PERMIT

SEWAGE DISPOSAL SYSTEM

SUBDIVISION Wellington LOT 9 ROAD 2855 Hunt Valley Drive

5 BED ROOMS
WELLINGTON LOT 9
4 TH ELECTION DISTRICT
HOWARD COUNTY, MARYLAND
SCALE 1" = 50' DATE NOV, 15, 1991
PLAT NO. 8946

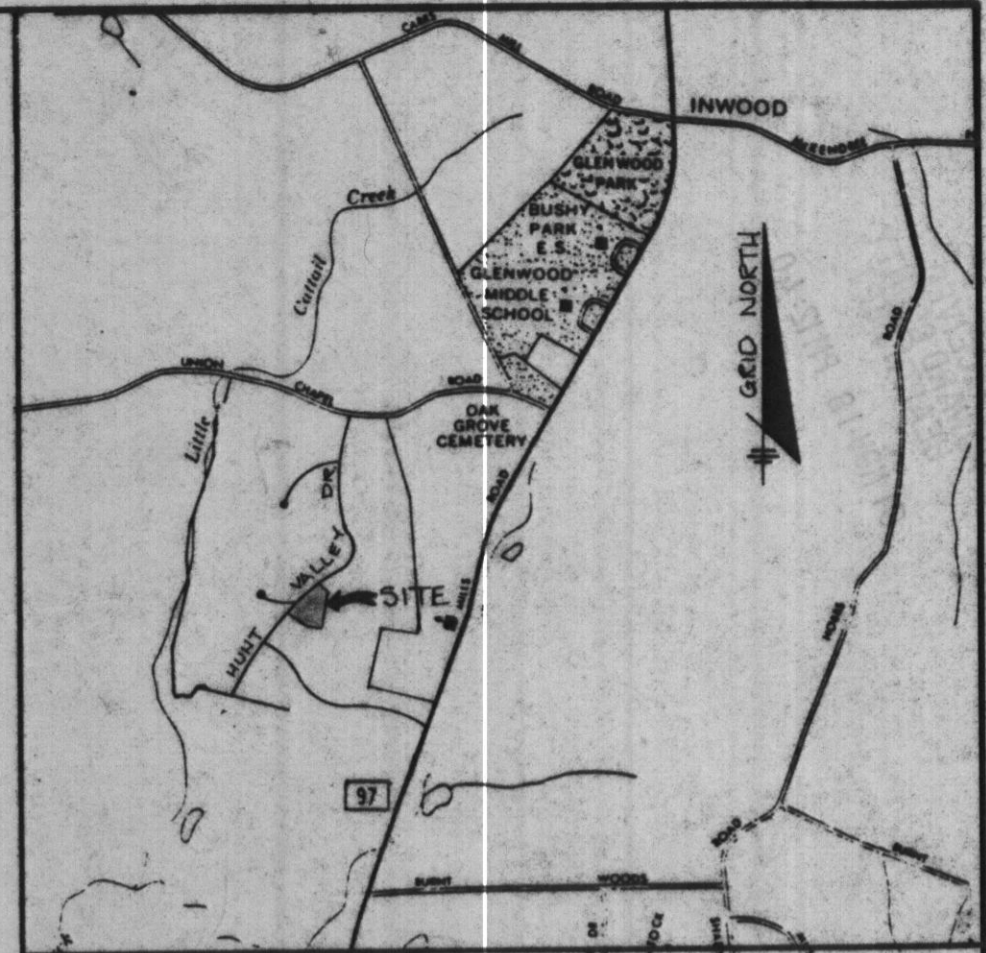
DISTRIBUTION BOX LEVEL No lot Trench inlet invert 1/2" higher than Tr 2+3

REMARKS: Trenches not properly spaced only 5-6 ft of unconsolidated earth between each trench.
Invert of Feeder Line at dist box not all level (#) is 1/2" too high. At midpoint all three trenches
pass thru a vein of rock (stone-boulder size of unweathered Gneiss) - DR. corrected to level - OK
to Love, Scott R/R 2-24-92

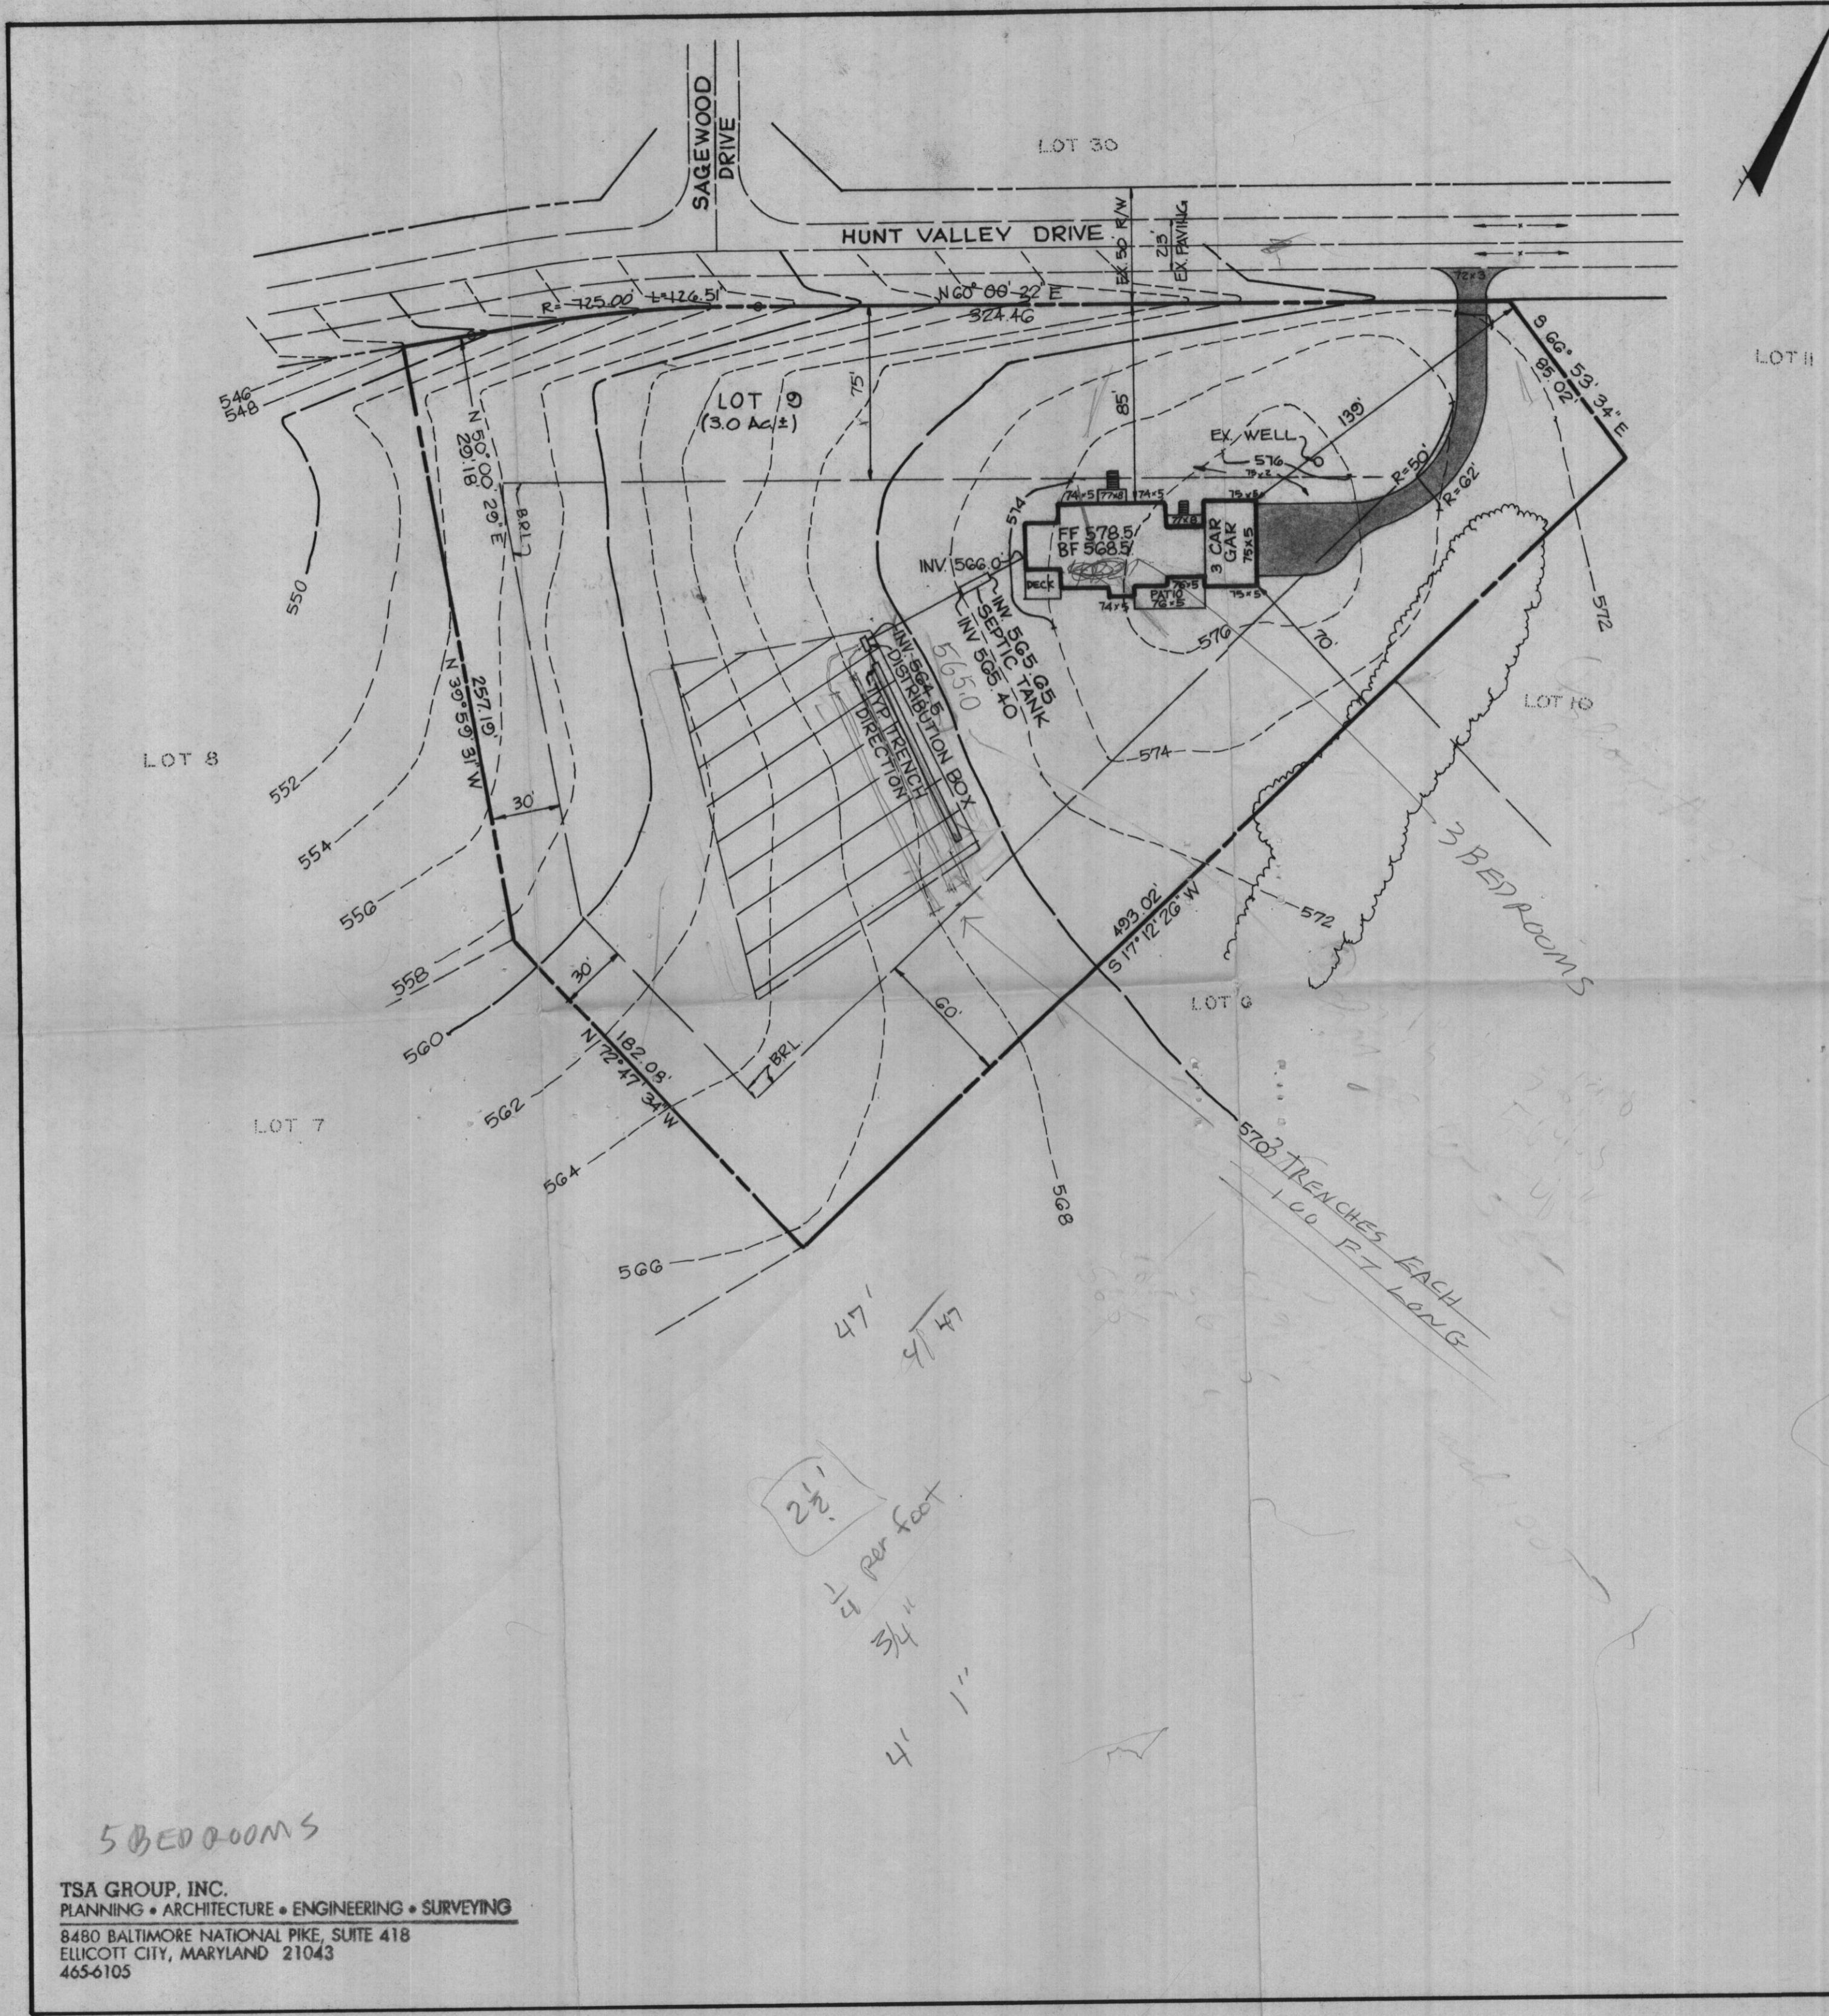
*Revised Plans
Corrected by Redlining
Talked to Engineer on phone*
